EYE WASH, DECK MOUNTED, SWING DOWN "AUTO FLOW" STYLE

SUBMITTAL IDENTIFICATION SHEET

WEBSTER UNIVERSITY ISB
PROJECT NAME

- ○ A. No Exceptions Taken
  No further review of submittal is required.
- ◉ B. Make Corrections Noted
  Incorporate corrections in work; resubmission is not required.
- ○ C. Revise and Resubmit
  Revise as noted, and resubmit for review.
- ○ D. Rejected
  Submittal is not in compliance with Contract Documents; provide new submittal.
- ○ E. For Record / Information Only
  Submittal was reviewed for Record / Information purposes only.
- ○ F. Not Required for Review
  Submittal is not required by Contract Documents and has not been reviewed.

CTEW849-WHT

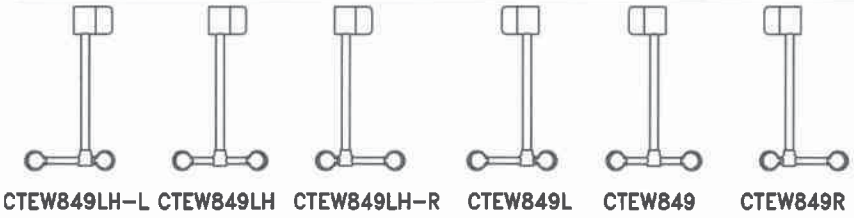
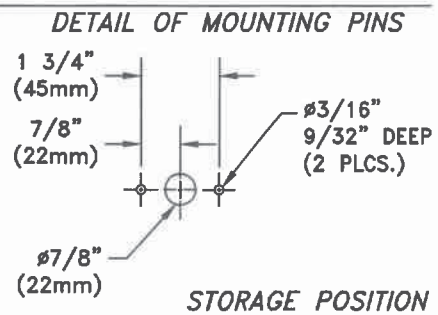
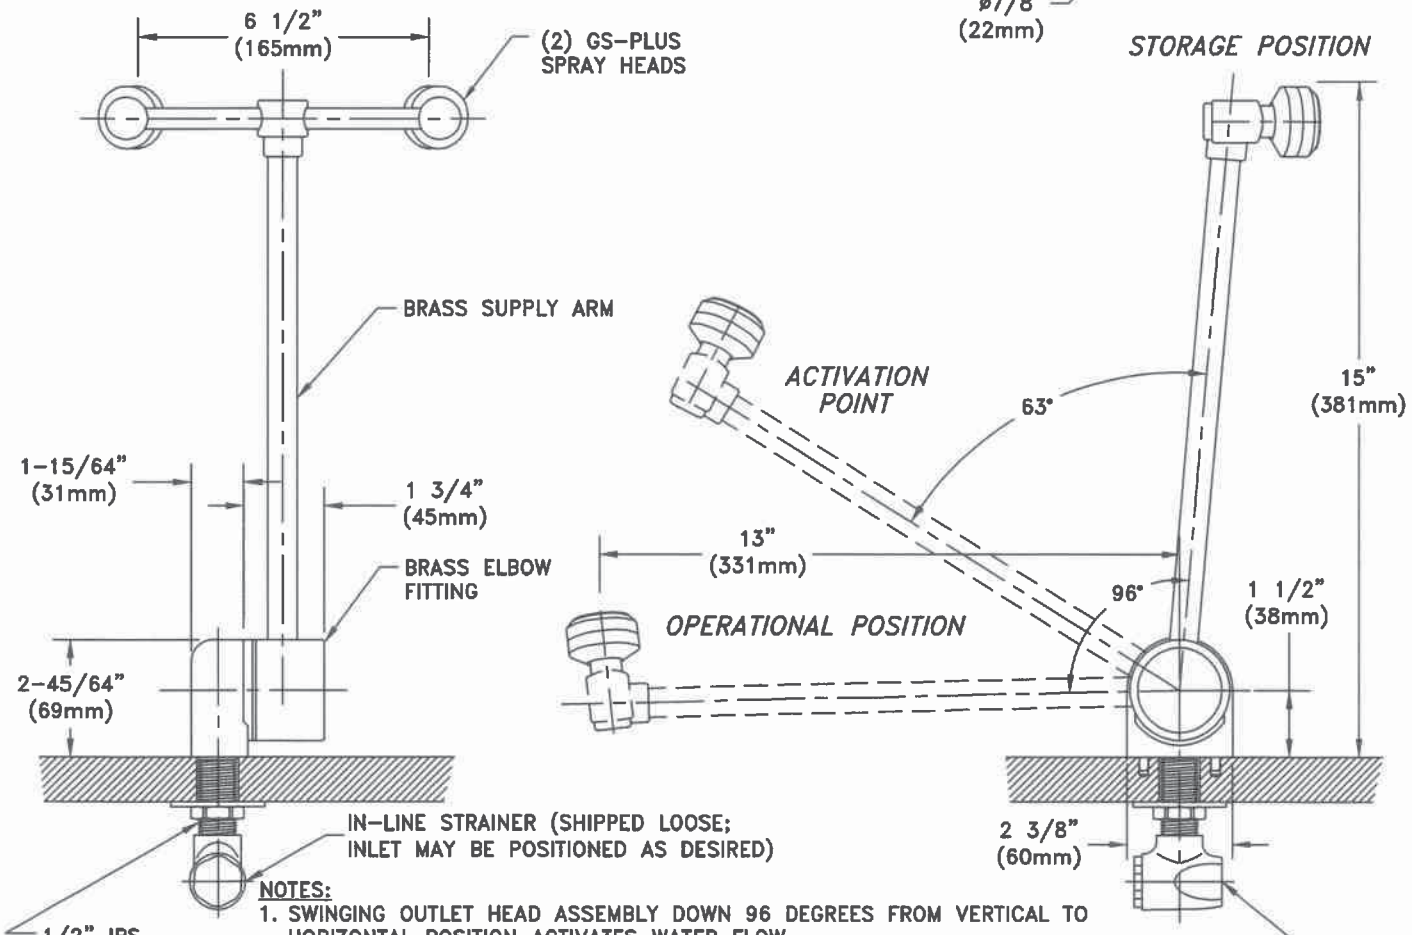
FIXTURE APPROVAL ON HOLD
- PLEASE CALL TO DISCUSS

FIXTURE MUST BE ADA-COMPLIANT

-EW, DH & PRE-RINSE FIXTURE APPROVAL ON HOLD.
